Access Compliance Report Public Rights-of-Way (Curb Ramps)

Intersection ID: 42401Main Street: GRIERS_GROVE_RDCross Street: MCALLISTER_DRLocation: WADA ID: 308BC5FEAB8FRamp Type: PerpInitial Pass/Fail: FailOverall Compliance: NoSeverity Score: 30

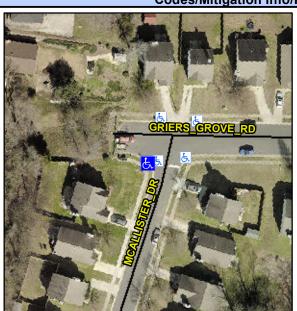
| 1 0331bic Ocidiioii | |
|-------------------------------|----------|
| Not Found, R304.5.1, R304.2.2 | N/ |

| Comp | liance Description | Data | Comp | liance Description | Data |
|------|-----------------------|------|------|-----------------------------|------|
| N/A | Ramp Length (in) | 52.0 | No | Ramp Slope (%) | 8.4 |
| No | Ramp Width (in) | 34.0 | Yes | Ramp XSlope (%) | 1.9 |

| 1 0331bic Ocidiioii | |
|-------------------------------|----------|
| Remove & Replace Entire Ramp. | N |
